**Economic and Social  
Council**Distr.  
GENERALECE/TRANS/WP.29/GRSP/2007/17  
28 September 2007Original: ENGLISH  
ENGLISH AND FRENCH ONLY**ECONOMIC COMMISSION FOR EUROPE**

REGULATION No. 94  
(Frontal collision)Proposal for draft amendmentsProposal submitted by France <sup>\*/</sup>

The text reproduced below was prepared by the expert from France in order to replace the deformable element face, to change the test speed and overlap. It is based on a document distributed without a symbol (GRSP-41-25) during the forty-first session of the Working Party on Passive Safety (GRSP) (see report ECE/TRANS/WP.29/GRSP/41, paras. 56 and 66). The

**Figure 1: Barrier dimensions.**

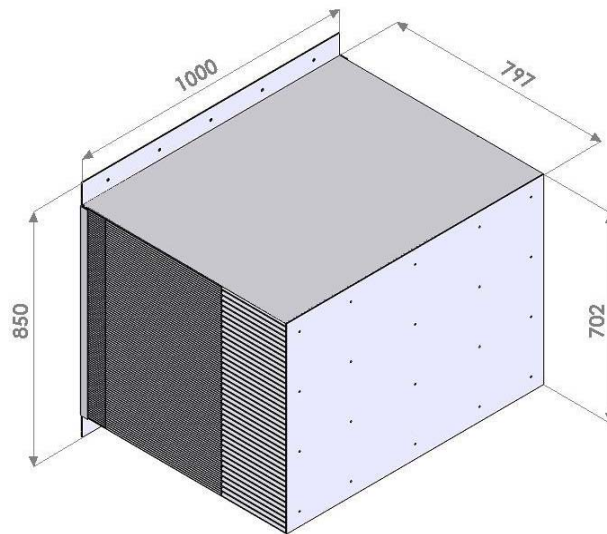
**Characteristics of the deformable barrier**

**The PDB deformable barrier is a stacking of three deformable aluminium honeycomb cores. The first (front deformable core, 250 mm thick) is designed to provide a constant load in depth. The second (progressive deformable core, 450 mm thick) is designed to provide a progressive load in depth. The third (back deformable core, 90 mm thick) is designed to provide a constant load in depth. Aluminium honeycomb cores are bonded together with different aluminium sheets forming a ready to use deformable barrier to be fixed on a rigid wall.**

**The PDB barrier is composed of the following components:**

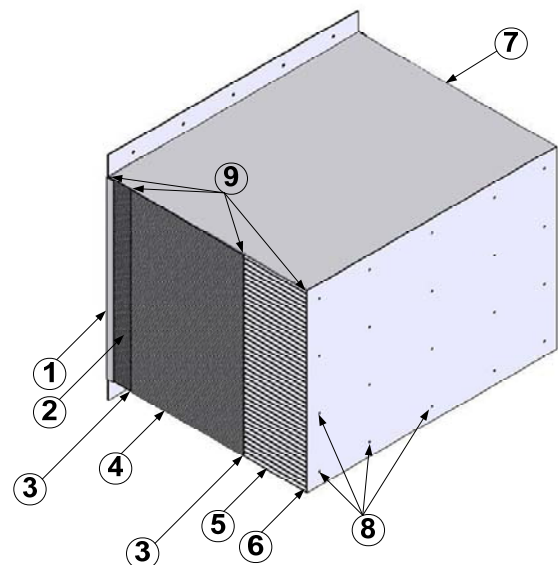
- (1) One back plate,**
- (2) One back deformable core,**
- (3) Two intermediate plates,**
- (4) One progressive deformable core,**
- (5) One front deformable core,**
- (6) One contact plate,**
- (7) One outer cladding,**
- (8) Blind rivets,**
- (9) Epoxy resin.**

**1.1. Back Plate geometrical and material characteristics (1)**

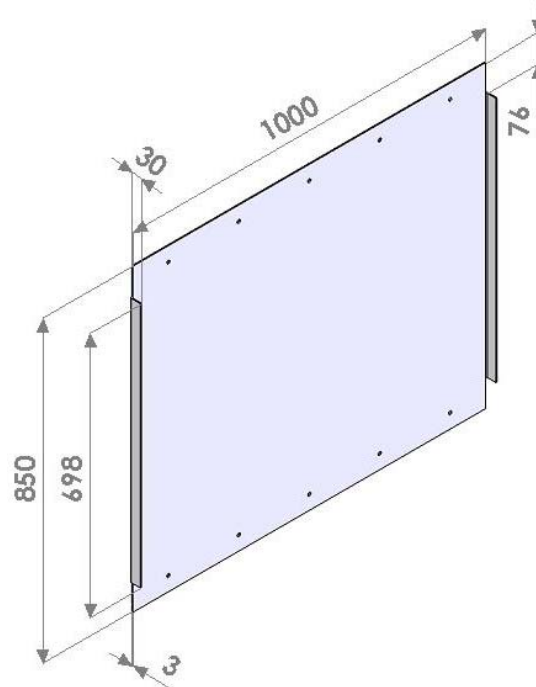
The back plate is  $1000 \pm 2.5$  mm wide and  $850 \pm 2.5$  mm high. The thickness is 3 mm. The back plate is manufactured from Aluminum of 1050A H14.

**1.2. Intermediate Plate geometrical and material characteristics (3)**

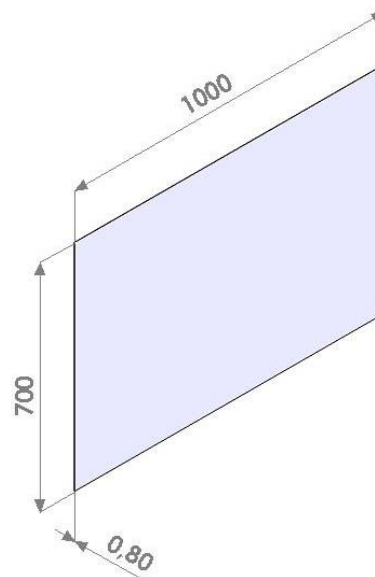
The intermediate plate is  $1000 \pm 2.5$  mm wide and  $700 \pm 2.5$  mm high. The thickness is 0.5 mm. The back plate is manufactured from Aluminum of 5754 H111.

**1.3. Contact plate geometrical and material characteristics (6)**

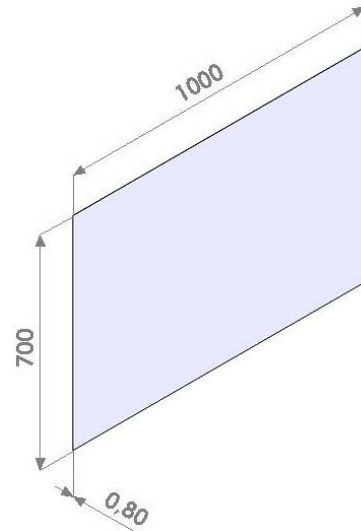
The contact plate is  $1000 \pm 2.5$  mm wide and  $700 \pm 2.5$  mm high. The thickness is 1.5 mm. The contact plate is manufactured from Aluminum of 1050A H24.

**1.4. Cladding geometrical and material characteristics (7)**

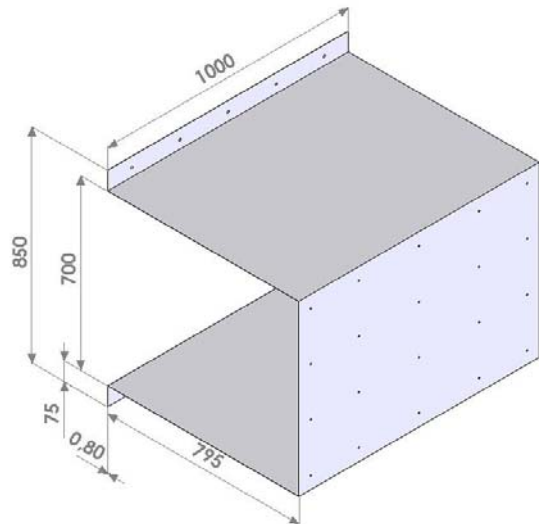
The cladding is  $1000 \pm 2.5$  mm wide and  $850 \pm 2.5$  mm high. The thickness is 0.8 mm. The cladding is manufactured from Aluminium of 5754 H22.

The cladding has two mounting flanges of 75 mm allowing rigid wall mounting. Twenty 6.2 mm holes shall be drilled through the outer cladding in order to accommodate front face blind rivets.

**1.5. Rivets position (8)**

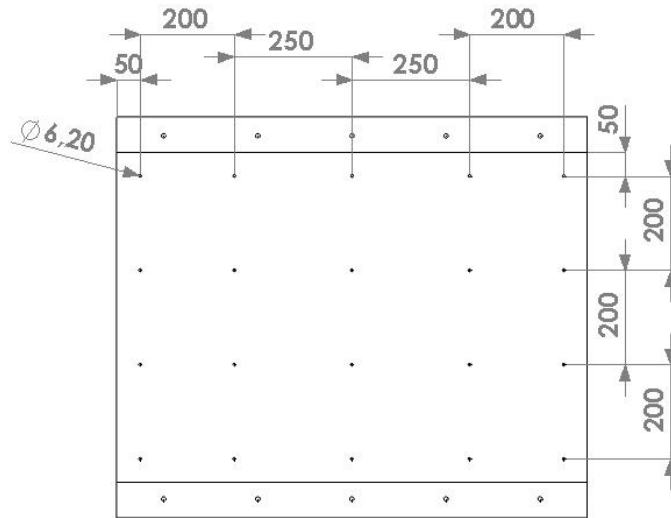
Twenty blind rivets shall be used to improve the link between outer cladding and contact plate. Rivets shall be aluminum/steel blind rivets diameter 6 mm.

**1.7.1. Front block (5)**

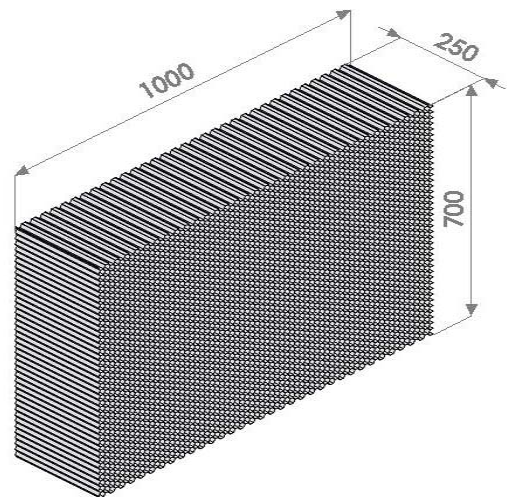
The front block (area #1) shall be  $700 \pm 5$  mm in L Direction,  $1000 \pm 5$  mm in W direction and  $250 \pm 1$  mm in T direction. The crushing characteristics of the front block are constant.

**1.7.2. Progressive block (4)**

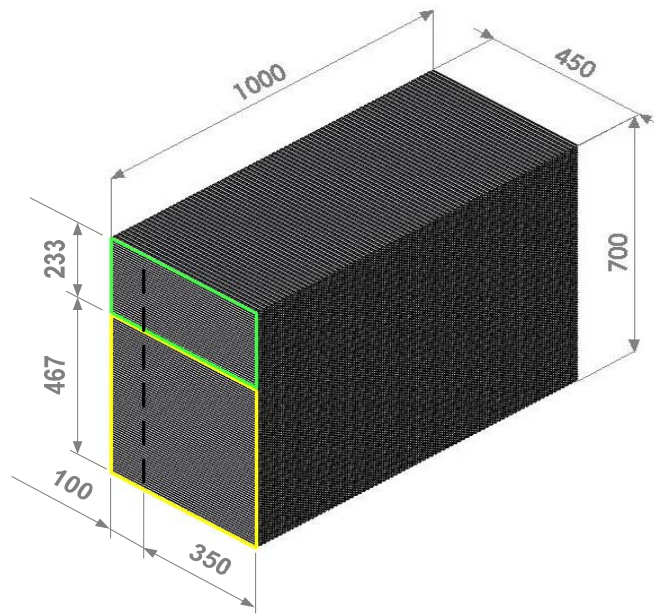
The progressive block (area #2 and #3) shall be:  $700 \pm 5$  mm in L direction,  $1000 \pm 5$  mm in W direction and  $450 \pm 1$  mm in T direction. The crushing characteristics of the progressive block present 2 different load paths. The lower load path #2, offers a progressive resistance in depth for first 350 mm and a constant resistance in depth for last 100 mm. The upper load path #3, offers a progressive resistance in depth for first 350 mm and a constant resistance in depth for last 100 mm.

**1.7.3. Back block (2)**

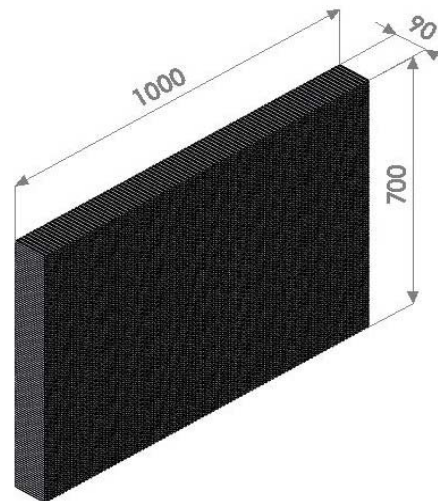
The back block (area #4) shall be  $700 \pm 5$  mm in L direction,  $1000 \pm 5$  mm in W direction and  $90 \pm 1$  mm in T direction. The crushing characteristics of the front block are constant.

**Figure 2: Crush strength specification for the different cores.**

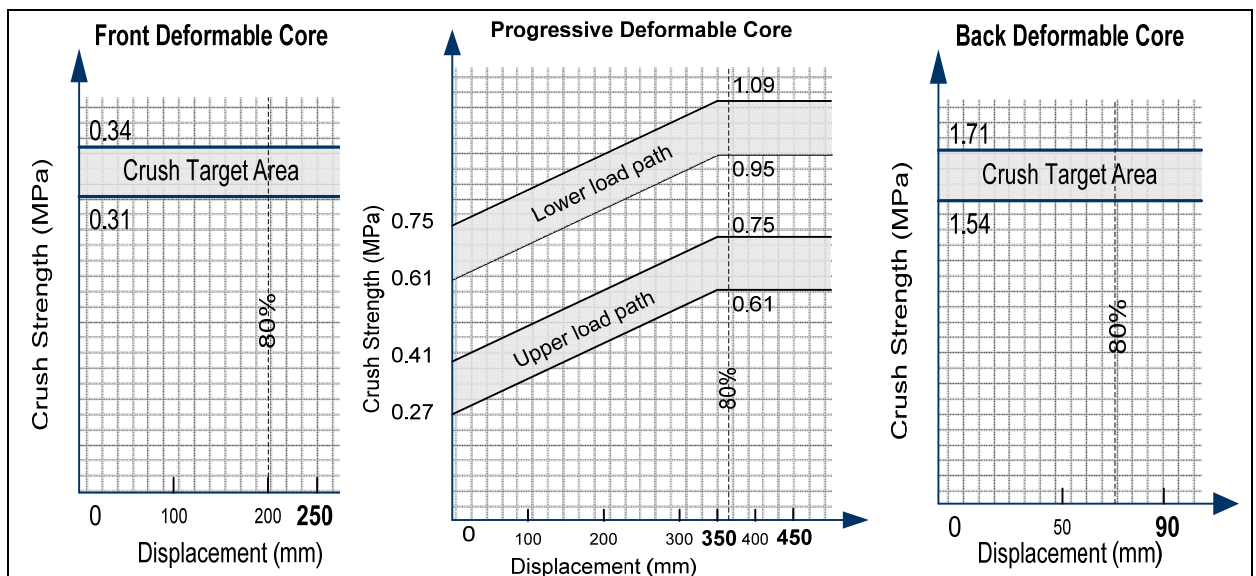
The crush resistance curve for each block tested shall be included within the corridors defined below:

Figure 3: Gluing detail among the different parts.

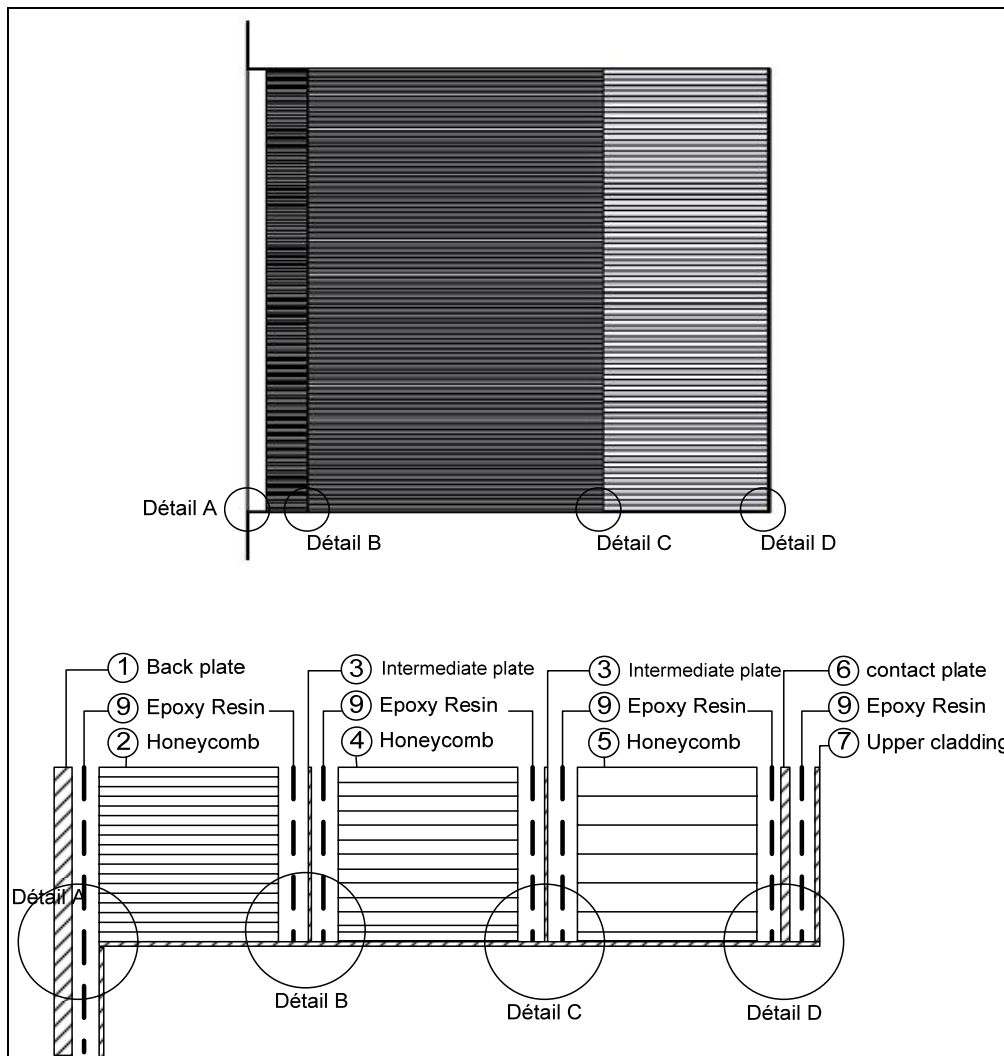
3.1. Immediately before bonding, aluminum sheet surfaces to be bonded shall be thoroughly cleaned using a suitable **cleaning and degreasing solution**. This is to be carried out as required to eliminate grease or dirt deposits. The cleaned surfaces shall then be abraded using 120 grit abrasive paper. Metallic/Silicon Carbide abrasive paper is not to be used. The surfaces shall be thoroughly abraded and the abrasive paper changed regularly during the process to avoid clogging, which may lead to a polishing effect. Following abrading, the surfaces shall be thoroughly cleaned again, as above. All dust and deposits left as a result of the abrading process shall be removed, as these will adversely affect bonding.

3.2. The adhesive should be applied to one surface only. In cases where honeycomb is to be bonded to aluminum sheet, the adhesive should be applied to the aluminum sheet only. A maximum of 0.5 kg/m<sup>2</sup> shall be applied evenly over the surface, giving a maximum film thickness of 0.5 mm.

**Figure 4: barrier mounting and ground clearance**

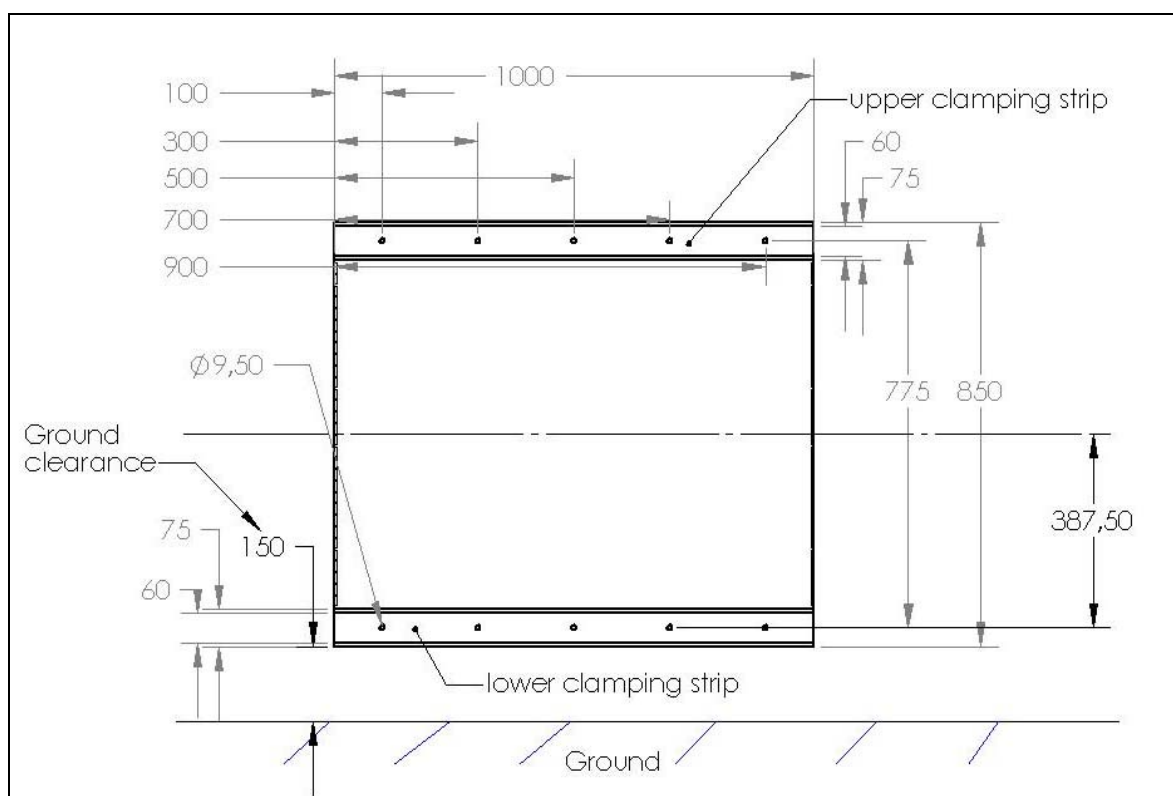
- 4.2. **Clearance holes for mounting the barrier are to be drilled in the mounting flanges (shown in Figure 4). The holes shall be of 9.5 mm diameter. Five holes shall be drilled in the top flange at a distance of 40 mm from the top edge of the flange and five in the bottom flange, 40 mm from the bottom edge of that flange. The holes shall be at 100 mm, 300 mm, 500 mm, 700 mm, and 900 mm from either edge of the barrier. All holes shall be drilled to  $\pm 1$  mm of the nominal distances. These hole locations are a recommendation only. Alternative positions may be used which offer at least the mounting strength and security provided by the above mounting specifications.**

maximum of 25 mm in order to accommodate differences in back-plate arrangements and/or load cell wall hole configurations. None of the fixtures shall fail in the impact test. In the case where the deformable barrier is mounted on a load cell wall (LCW) it **shall** be noted that the above dimensional requirements for mountings are intended as a minimum. Where a LCW is present, the mounting strips may be extended to accommodate higher mounting holes for the bolts. If the strips are required to be extended, then thicker gauge steel should be used accordingly, such that the barrier does not pull away from the wall, bend or tear during the impact. If an alternative method of mounting the barrier is used, it should be at least as secure as that specified in the above paragraphs. **The ground clearance of the front part of the barrier shall be 150 mm.**
